Groundwater Application Review Summary Form

Application # G- 18360

PUBLIC INTEREST REVIEW FOR GROUNDWATER APPLICATIONS

A. GENERAL INFORMATION: Applicant's Name: Weedbuck Farms County: Clackamas

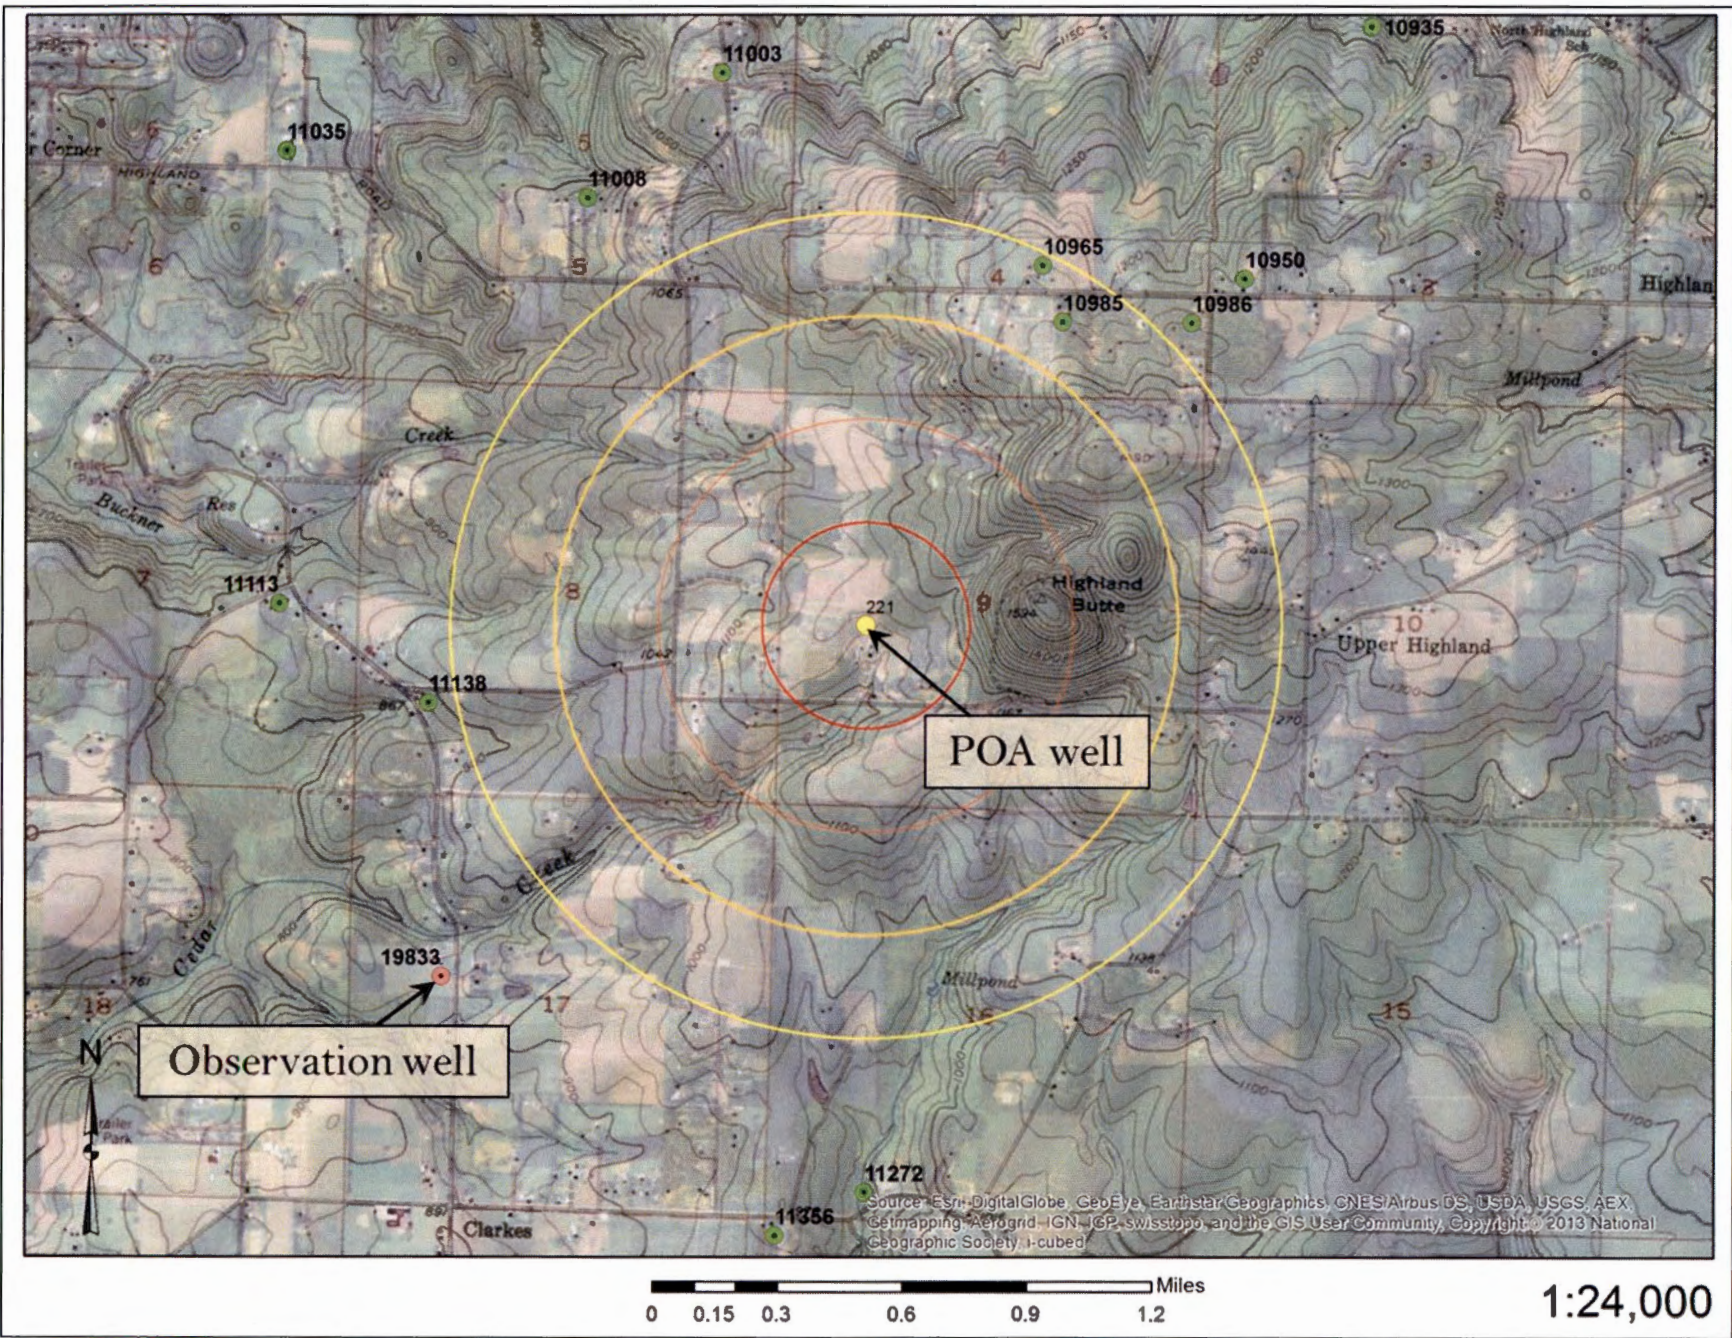
B3. **Groundwater availability remarks:** Nearby well CLAC 19833 (located about 7,000' SW of the proposed POA well) produces groundwater from Boring Volcanic Field lavas, and demonstrates stable water levels for two decades (see attached hydrograph).
